CITY OF CLE ELUM

Site & Design Review / Floodplain / SEPA SDR-2020-005 / FP-2020-003 / SEP-2020-007

FINAL PERMIT PACKAGE

PROJECT:	Garnet Ledge Investments storage facility SDR-2020-005, FP-2020-003 & SEP-2020-007
APPLICANT: (Property Owner)	Garnet Ledge Investments LP PO Box 946, Roslyn Cle Elum, WA, 98922 509-572-7721
DESCRIPTION:	An 8,000 sf pre-manufactured steel building to be operated as a climate-controlled and dry wine storage facility, with 46 new or adjusted parking spaces within the area known locally as the Swiftwater Business Park.
LOCATION:	400 Swiftwater Blvd Cle Elum, WA 98922
PARCEL NUMBER:	123134
ZONING:	General Commercial
APPLICATION TYPE:	Type II
PREPARED BY:	Lucy Temple, Planner
DATE:	December 29, 2020
DECISION:	Garnet Ledge storage facility project APPROVED per attached final permit for SDR-2020-005, FP-2020-003, SEP-2020-007.
APPEAL:	The appeal process for Type II decisions is found in CEMC 17.100.130

JOB NO.	20010
DATE	NOV 2020
SCALE	AS SHOWN
DESIGNED	TJS
DRAWN	TJS
CHECKED	RBN
APPROVED	RBN
SHEET	C1.0

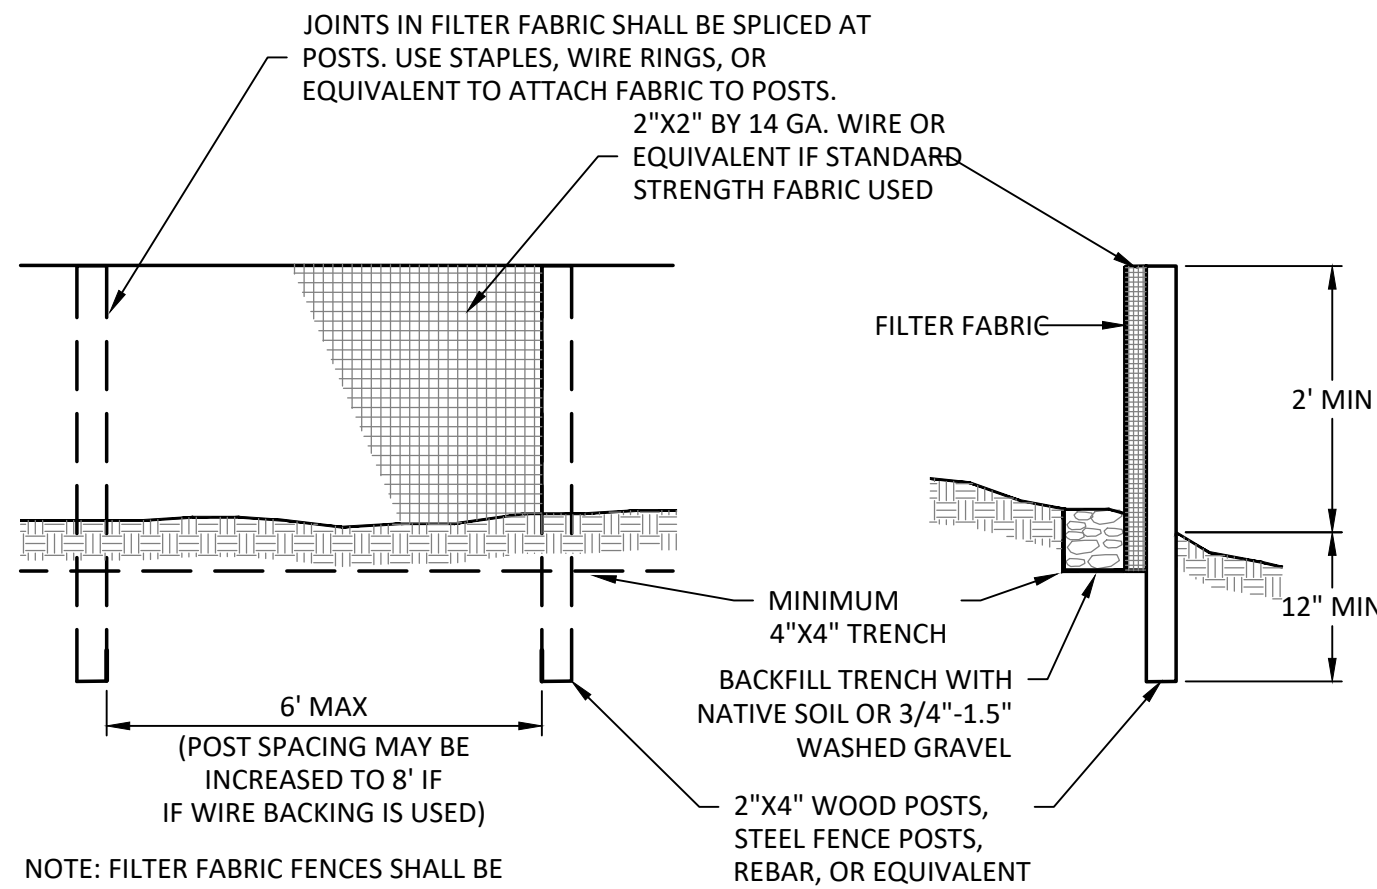
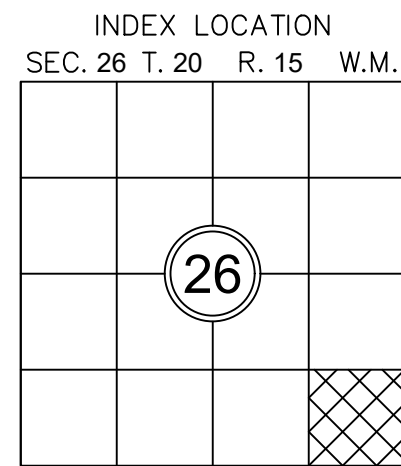
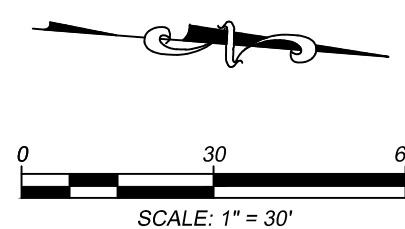
3. The narrative identifies that a boundary line adjustment was processed in 2020 to accommodate the proposed building. There is conflicting information on the plans, specifically on Sheet C1.0 that shows a boundary line through the building site. We recommend including the topographic survey in the plan set to identify complete boundaries with access and utility easements shown for proposed utility lines and access points. There appears to be an existing easement accommodating a gas line, and it should be confirmed this easement can contain the proposed public water main as well.

1. Sheet C0.0 – The new water service is mislabeled on the east side of the proposed building.
2. Sheet C1.0 – Add inlet protection to the catch basin on the west side of the access road and consider providing protection for the associated existing swale.

JOB NO. 20010
DATE NOV 2020
SCALE AS SHOWN
DESIGNED TJS
DRAWN TJS
CHECKED RBN
APPROVED RBN
SHEET C2.0

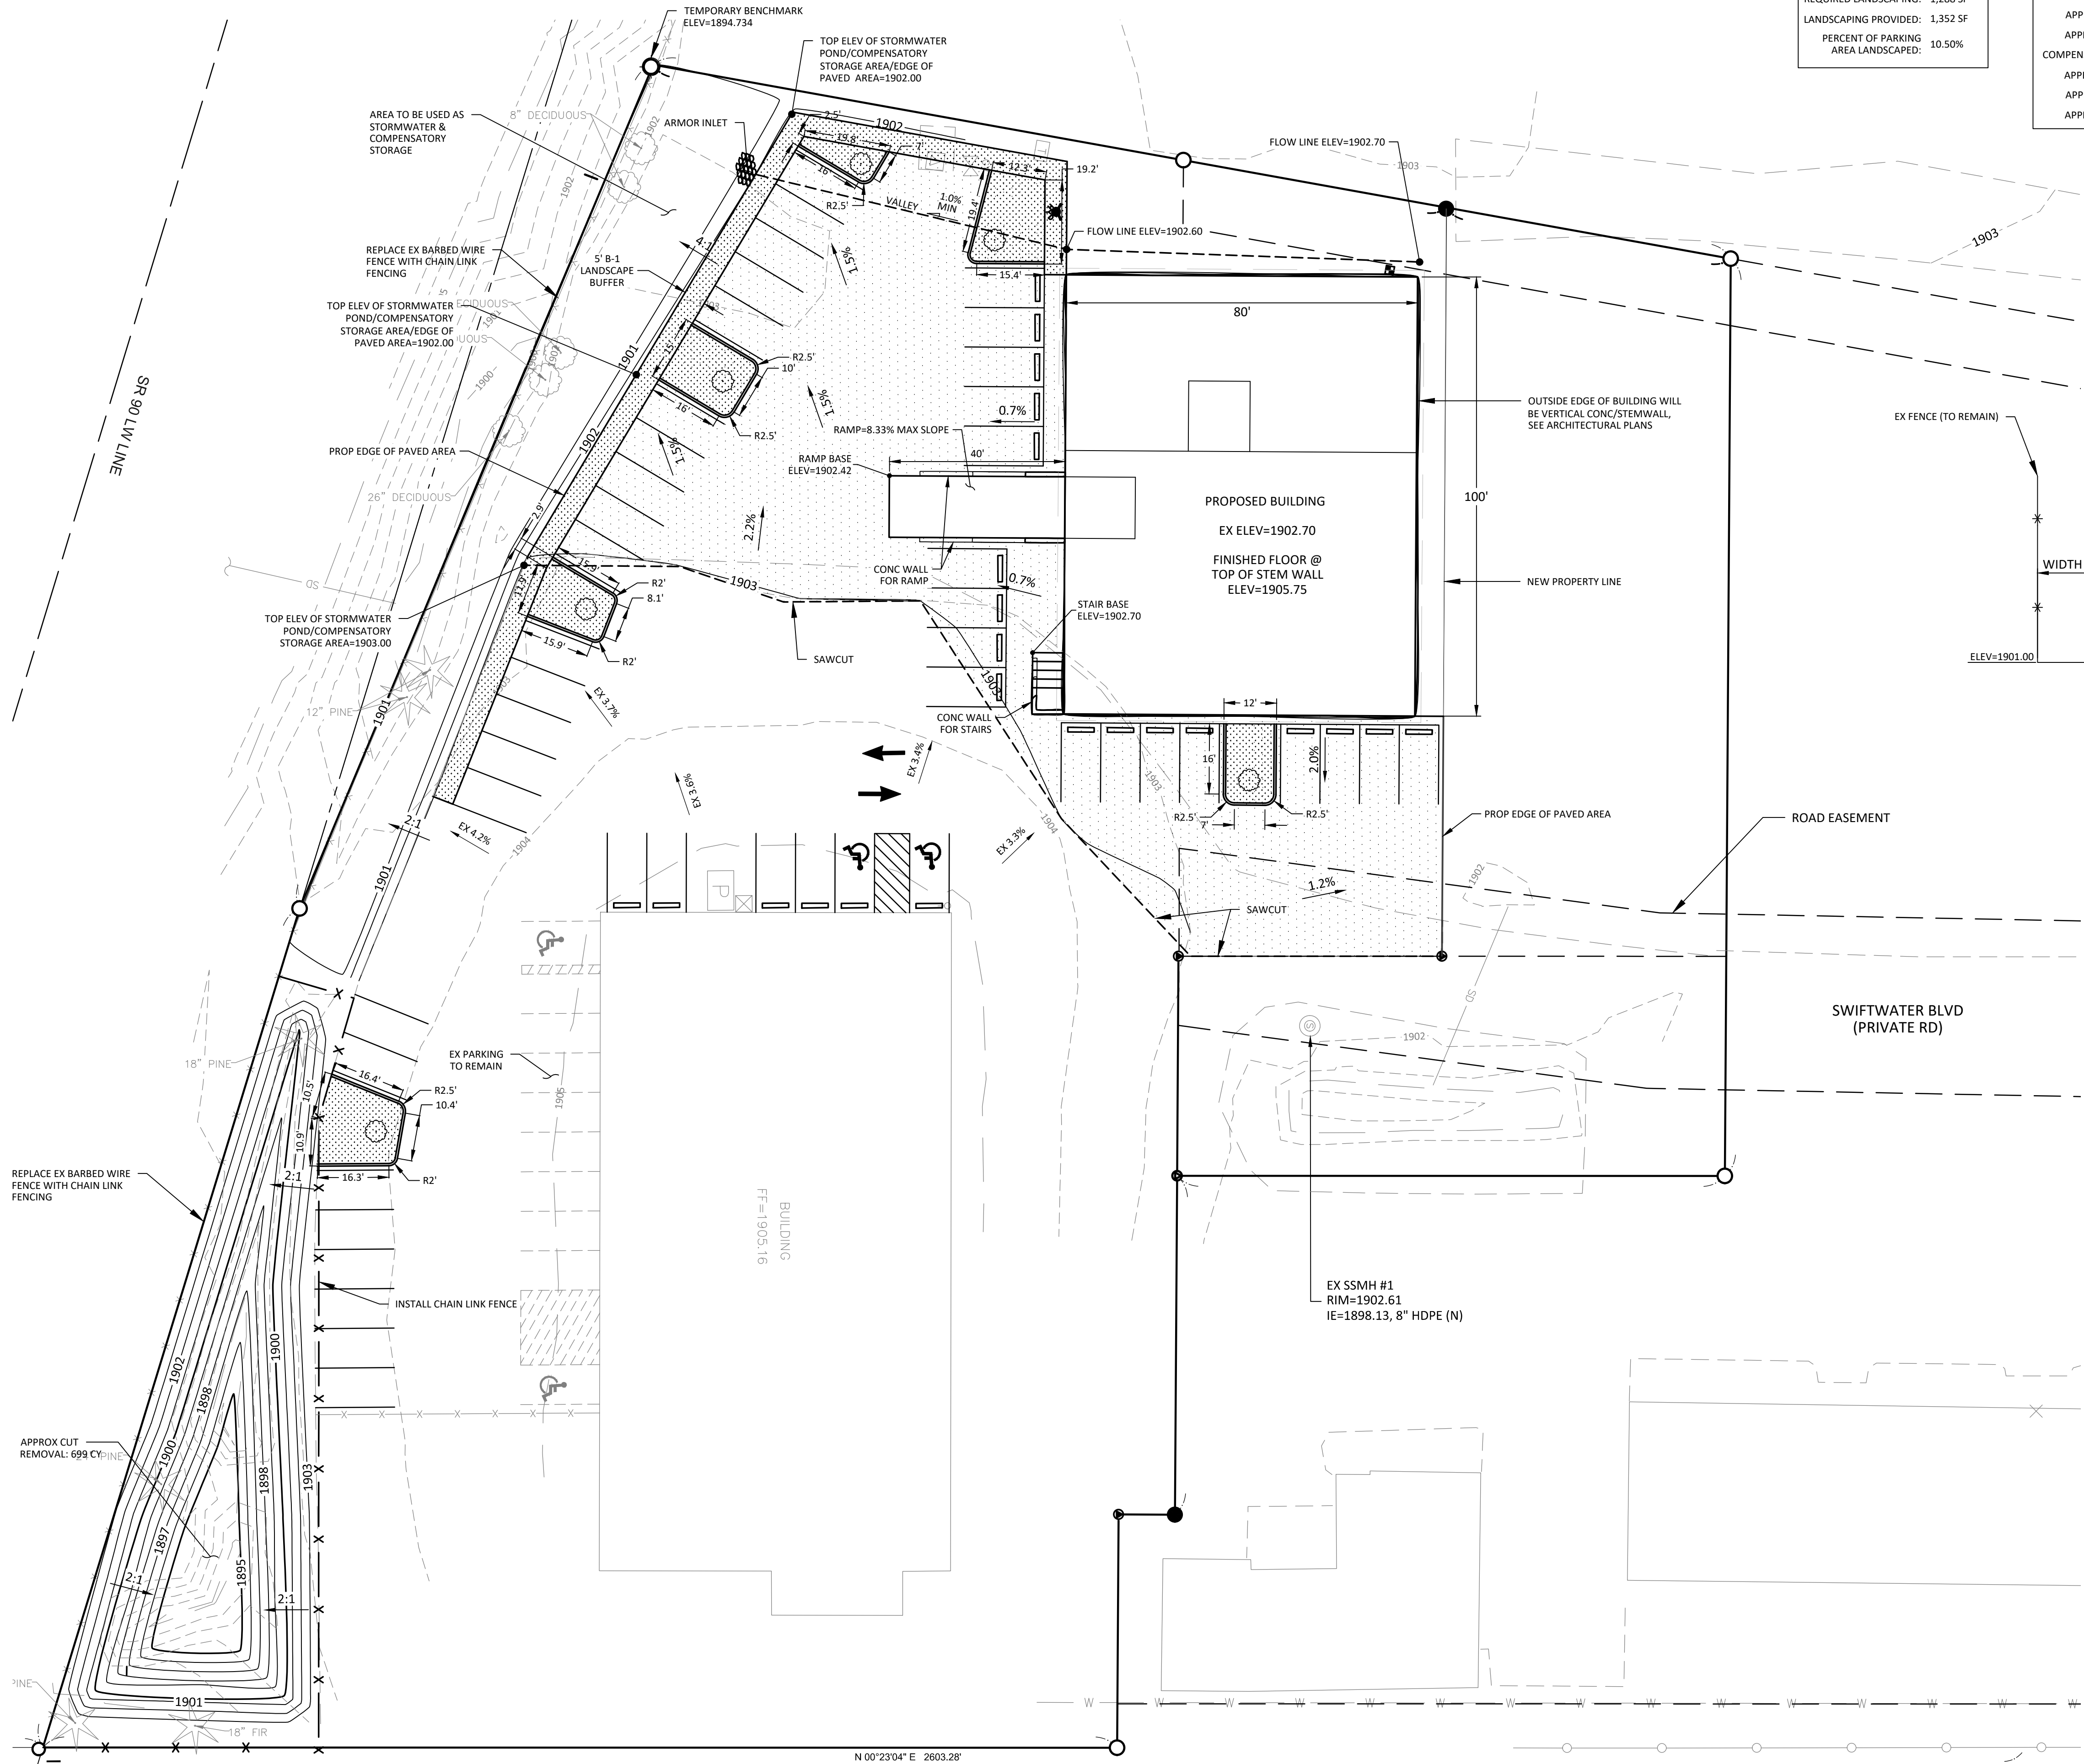
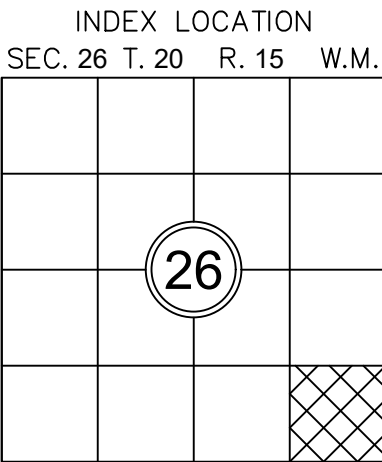
3. Sheet C2.0 – The accessible parking shown appears to be in existing paved areas with cross slopes exceeding maximum standards of 2.0%. Additionally, it is located adjacent to an existing building. The Cle Elum Municipal Code should be reviewed to confirm if accessible parking can be shared between buildings and uses.

4. Sheet C2.0 – The site cross section states the existing fence is to remain, while new chain link fence is proposed.
5. Sheet C2.0 – Curbing shall be installed adjacent to landscaped areas consistent with CEMC 17.64.050(D).

6. **Landscape Plan and Construction.** Landscaping shall adhere to [CEMC 17.64](#).
 - a. **Landscaping Islands.** Curbs should be shown on plans. A cross section of landscape islands and perimeter buffers shall be submitted and approved prior to constructing landscape islands. See Staff Response #9 above.

JOB NO.	20010
DATE	NOV 2020
SCALE	AS SHOWN
DESIGNED	TJS
DRAWN	TJS
CHECKED	RBN
APPROVED	RBN
SHEET	C3.0

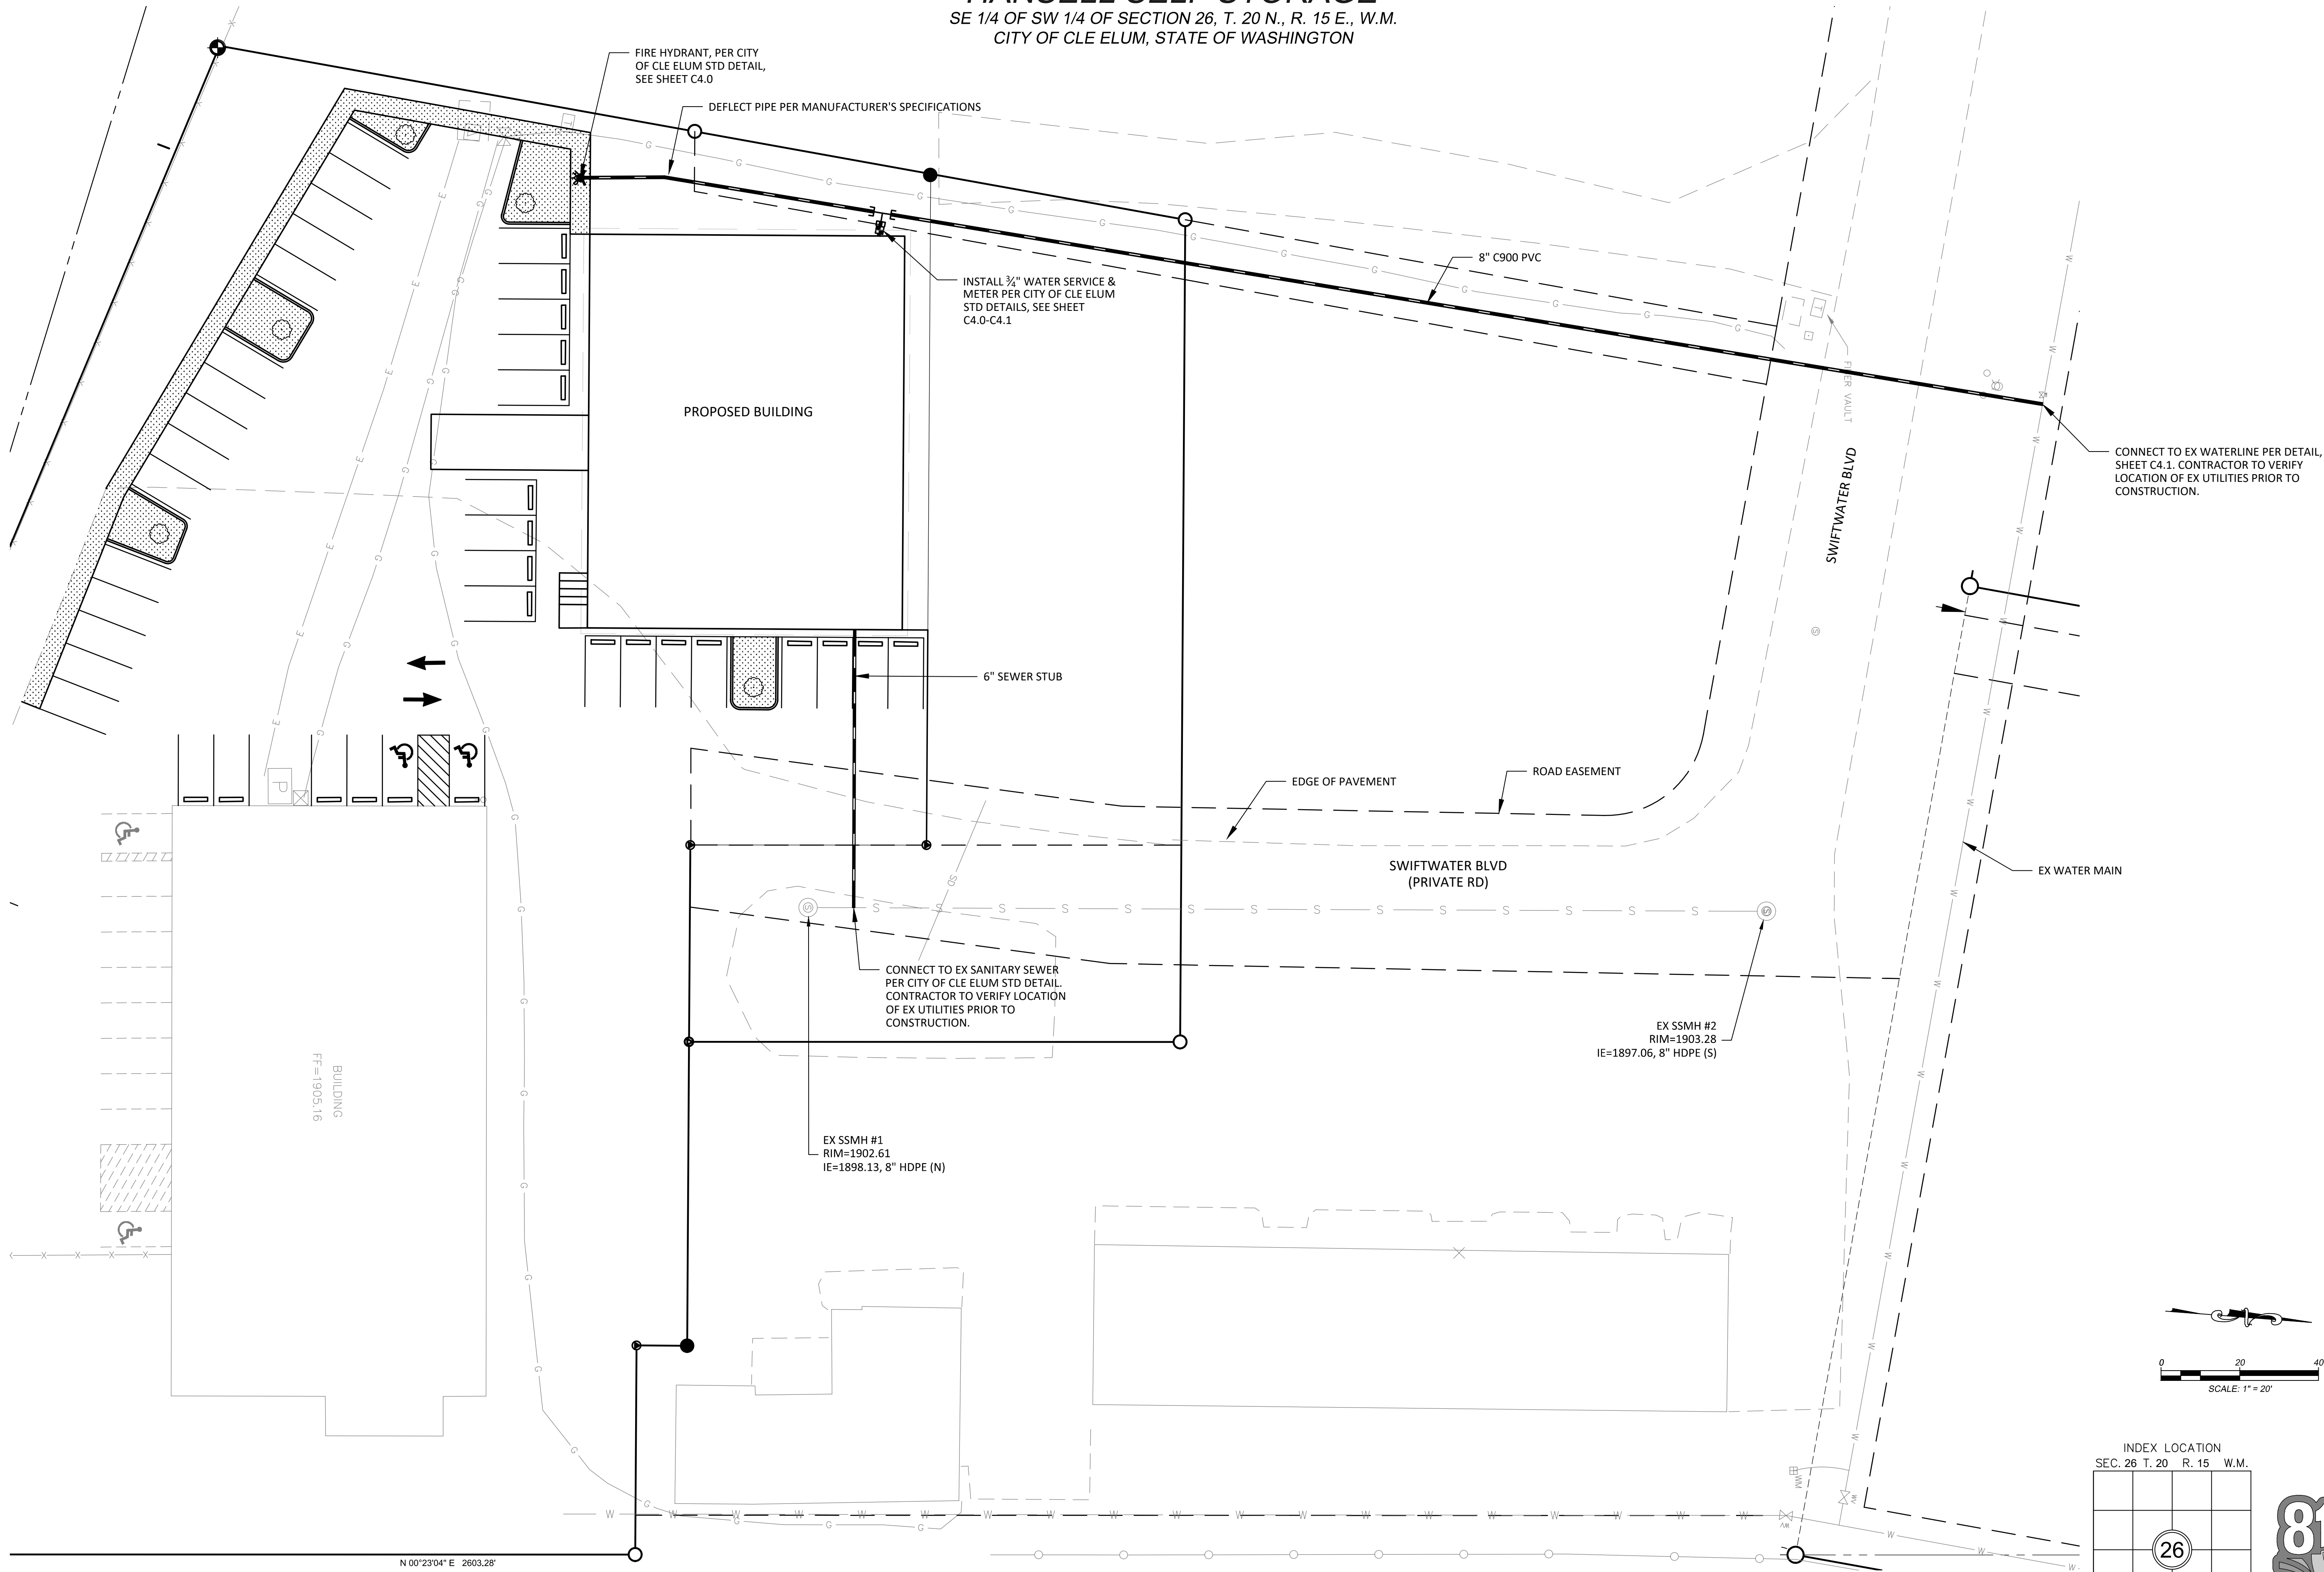
6. Sheet C3.0 – One hydrant is proposed at the southwest corner of the new building. We recommend the fire chief review this location to ensure it is not too close to the building. Also, it is our understanding the original approved plans for the Swiftwater development included a hydrant near the northwest corner of the existing building, but it was never installed by the developer. We recommend the fire chief review the hydrant coverage of the overall site to determine adequacy, and any other additional hydrants that may be required.

City Public Works, Building, and Fire departments reviewed the submitted civil plans and determined the fire hydrant must be moved to meet fire safety. The proposed location and confirmation from the Cle Elum Fire Chief are found in Exhibit 6. See also the project conditions below.
